# LiDAR Quality Assessment Report

## LA Barataria 2.0 meter LiDAR

Project: LA Barataria 2.0 meter LiDAR

Contractor: Digital Aerial Solutions

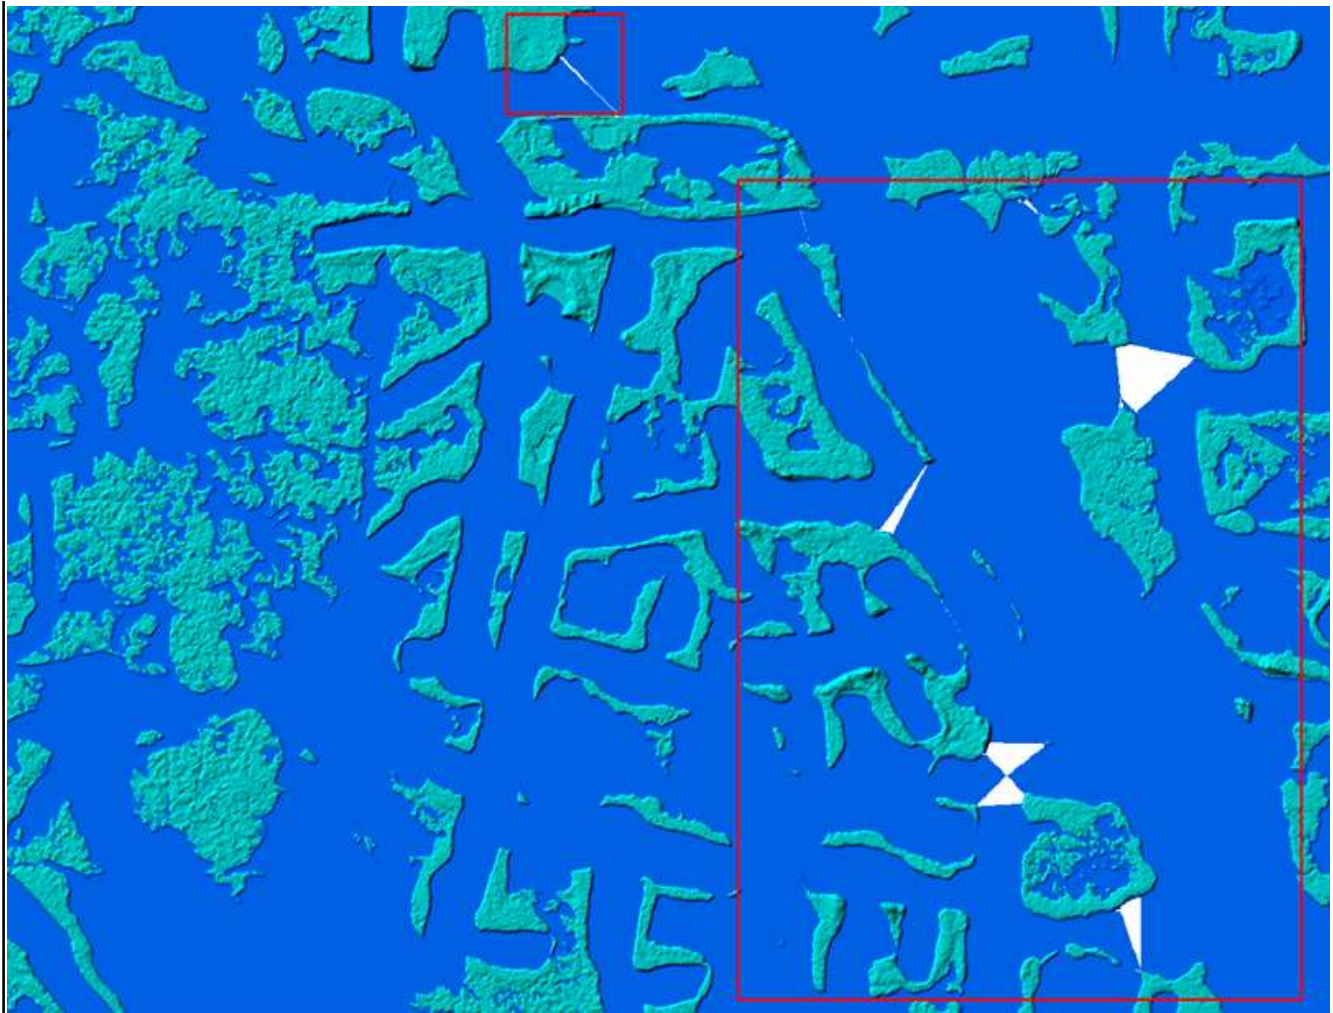
Tiles are free from Data Holidays (*voids due to processing or collection errors*)

Several areas of missing data exist, although points exist here in the swath data. See error shapefile for locations of missing data.

### Error was fixed by contractor

Tinning of land across waterbody:

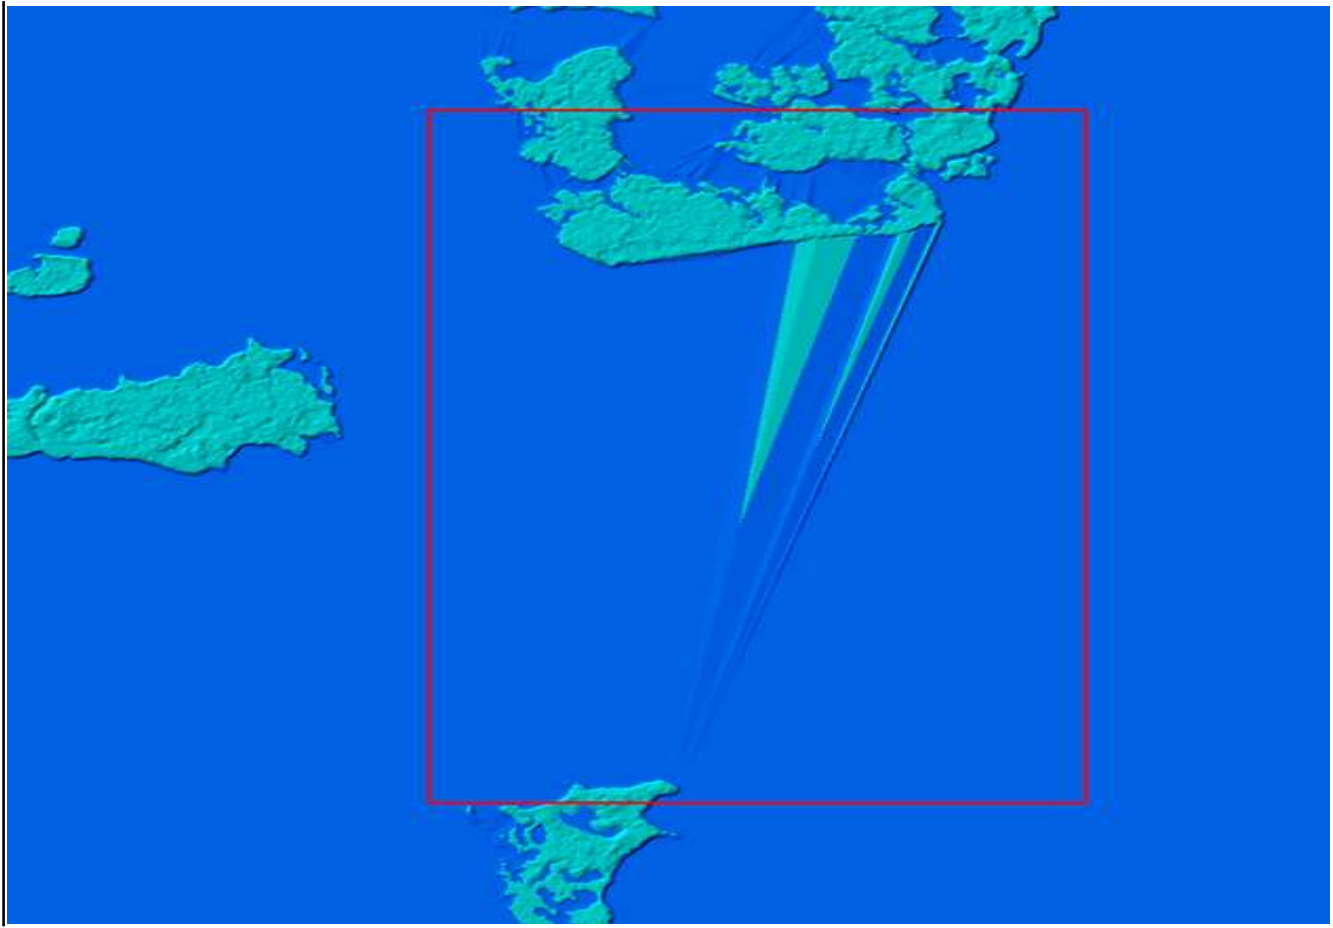
DEM tiles are properly Hydro Flattened  Yes  No

Waterbodies  or greater are flattened

**Error was fixed by contractor**
